**FAQ 21-01: Unplanned Scrams with Complications for AP1000
Final Approved**

Performance Indicator: IE04, Unplanned Scrams with Complications (USwC)

This FAQ seeks to implement changes to NEI 99-02 based on a whitepaper approved by the NRC at a Reactor Oversight Process (ROP) public meeting on November 18, 2020 (white paper is available in ADAMS with accession number ML20322A339; NRC meeting summary documenting the approval is available with accession number ML20339A592). The text of the FAQ describing the proposed changes below is copied from that whitepaper.

**IE04 Unplanned Scrams with Complications – Flowchart
Figure 2**

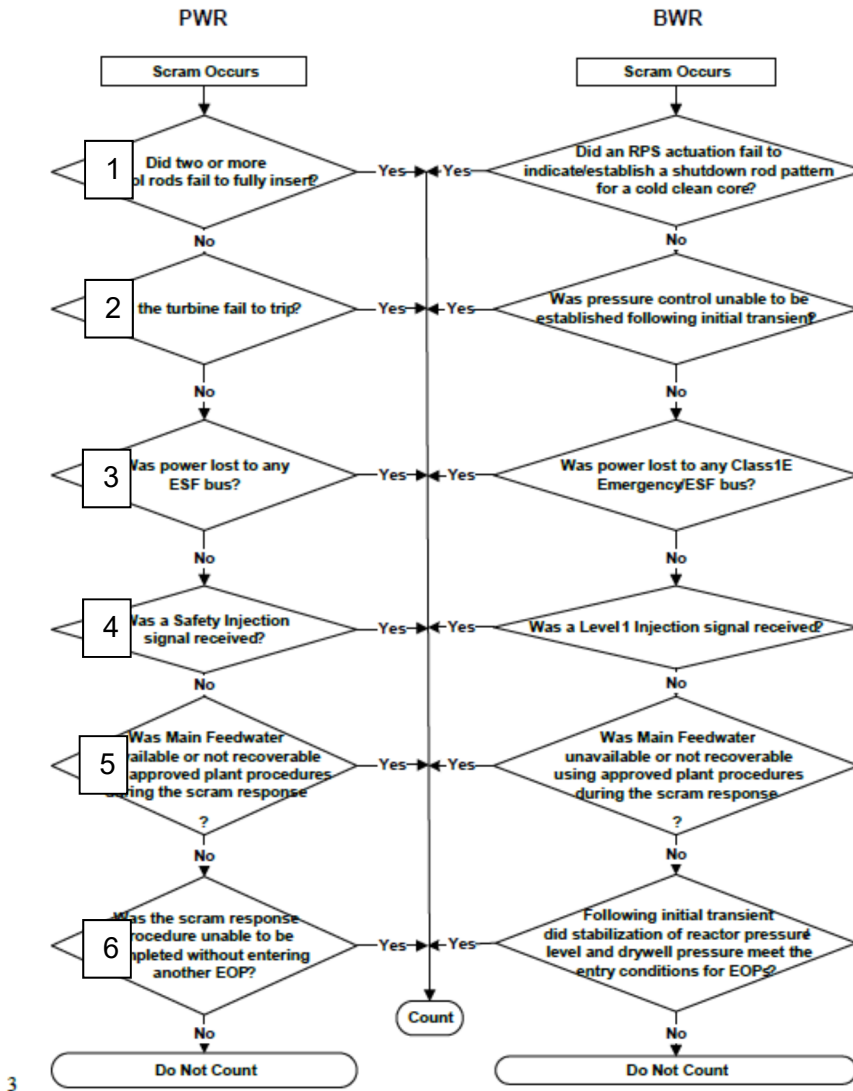
5. Conforming changes are needed in the depiction of PWR scram screening questions in Figure 2, as follows:

- a) For the third decision diamond, which reads, “Was power lost to any ESF bus?”, add the following footnote: “For AP1000: Was power lost to any battery backed Class 1E DC and UPS System (IDS) bus?”
- b) For the fourth decision diamond, which reads “Was a Safety Injection signal received?”, add the following footnote: “For AP1000: Was a Safeguards Actuation signal received?”
